Product / Process Change Notification

N° PCN 2018-073-A

Pin 1 Orientation Change to Comply with EIA-481 for PG-WSON-6

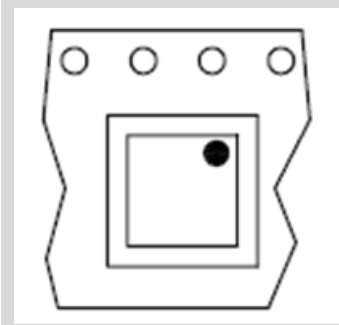
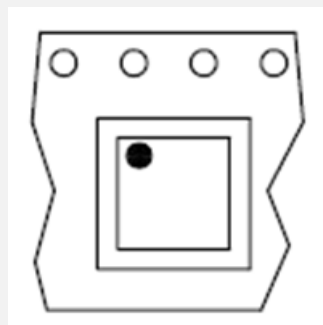
Subject: Pin 1 Orientation change from upper left to upper right to comply with industrial (EIA-481) standard for PG-WSON-6 package.

Reason: To comply with industrial (EIA-481) packing standard.

Old

New

■ Pin 1 at Upper Left

■ Pin 1 at Upper Right

No impact on electrical performance of the products as only the packing of the products will be changed. However, there may be a potential orientation adaption needed for automated pick and place manufacturing.
